City of Pasadena
Department of Water and Power

ADDENDUM NO. 5
to

Specifications LD-13-14
for

PROVIDING LABOR AND MATERIALS FOR
GLENARM REPOWERING BALANCE OF PLANT DESIGN AND CONSTRUCTION

Enclosures:	Figure 1	Probabilistic & Deterministic MCE and Lower Limit
	Figure 2	Final Design Spectrum According to Table 3.4.1

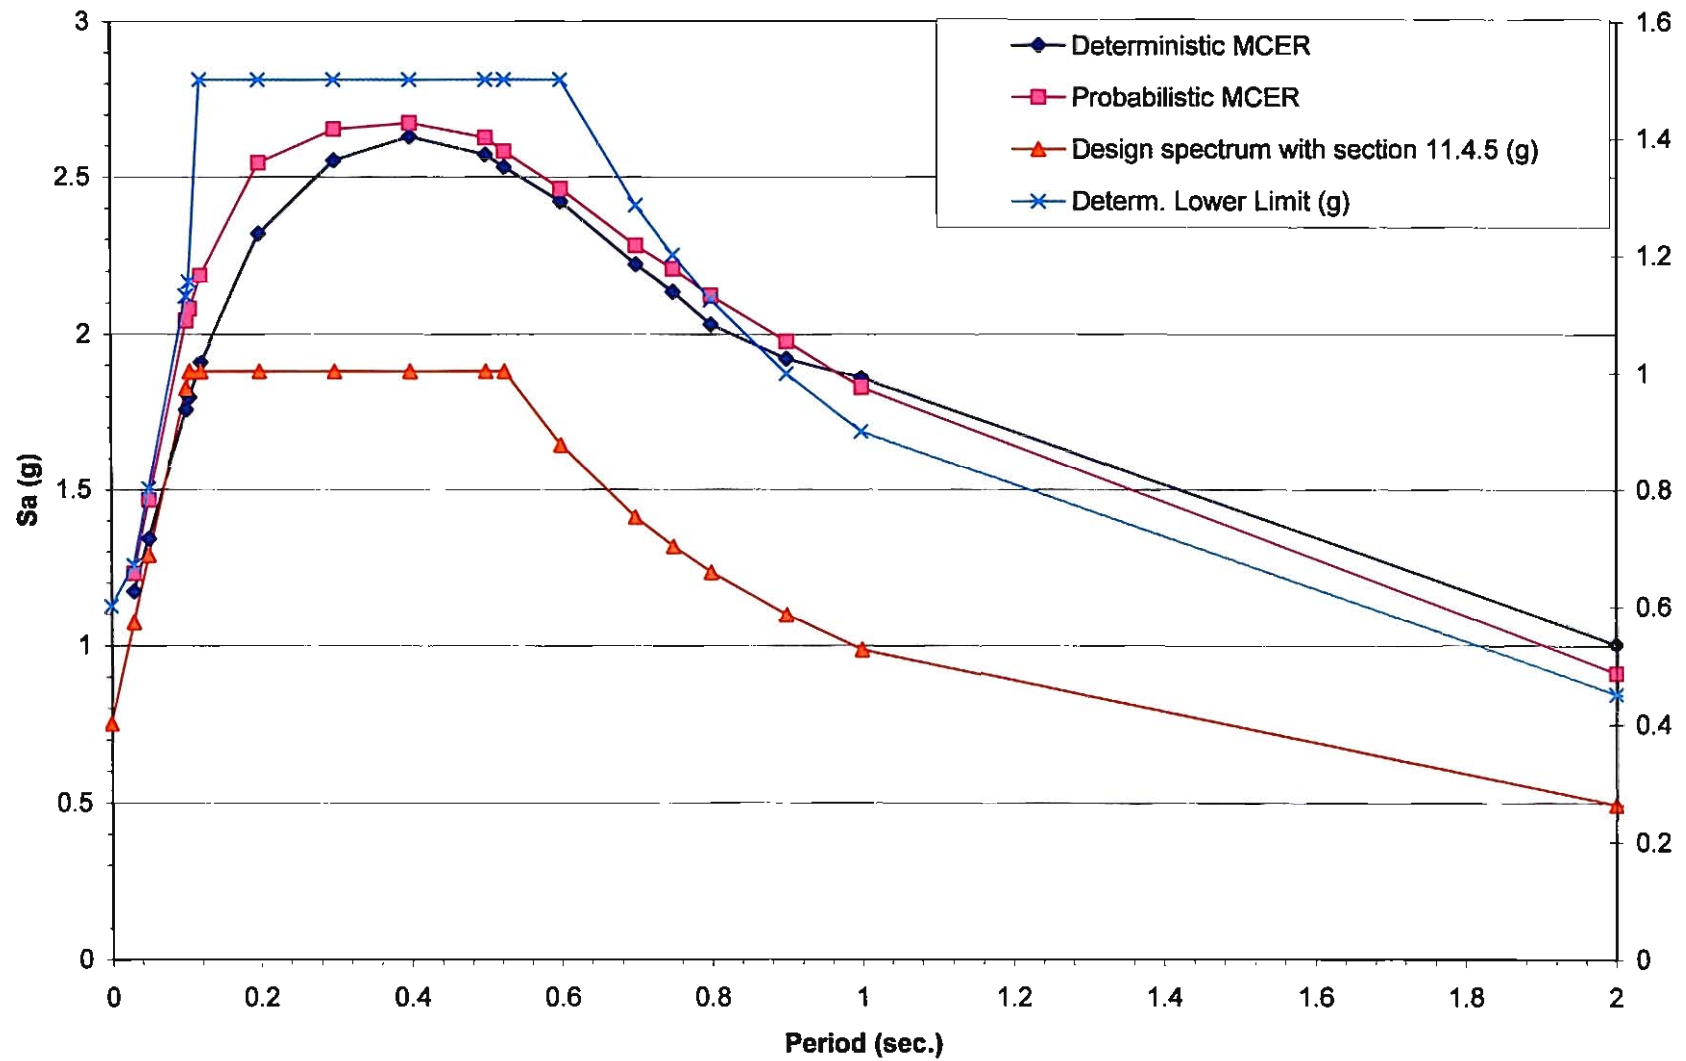
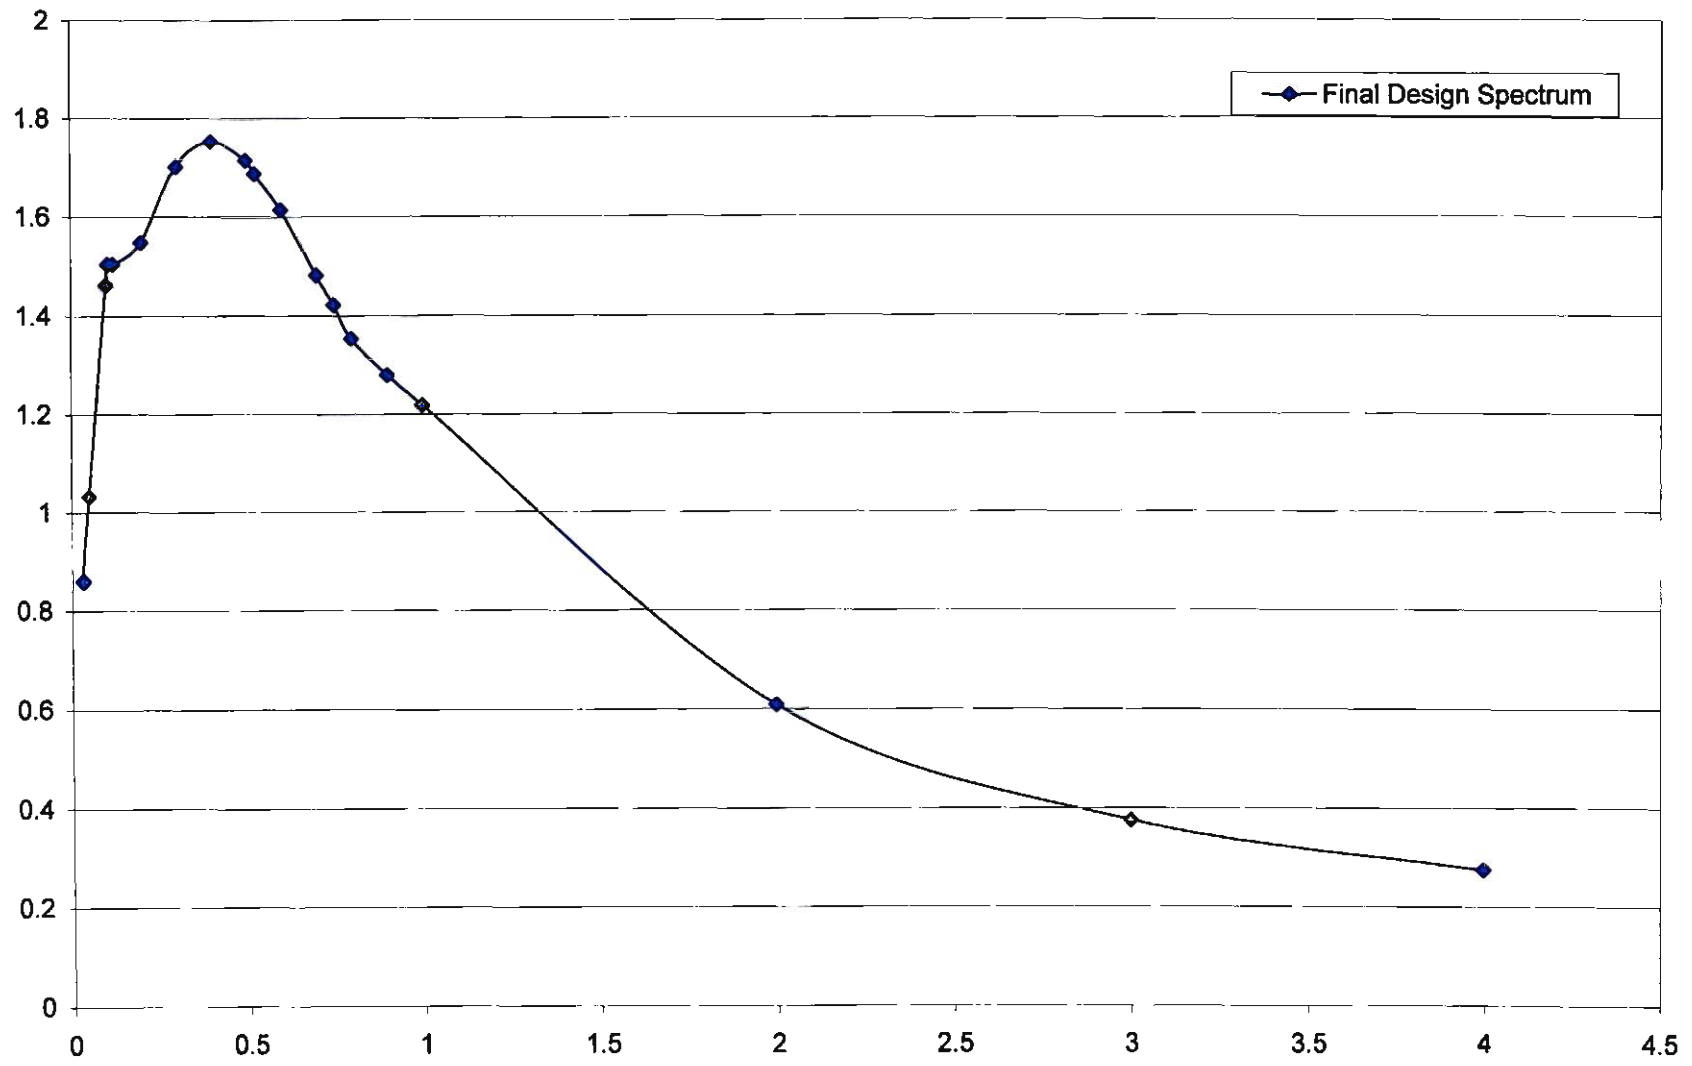
7. Delete Part 3 Section C of Specification 480020 in Attachment A.2.B Construction Specifications. Add to Part 3 Section G of Specification 480020 in Attachment A.2.B Construction Specifications a new item 3, Glenarm Revised Seismic Calculations, to be used in place of Part 3 Section C. See Enclosure 5.
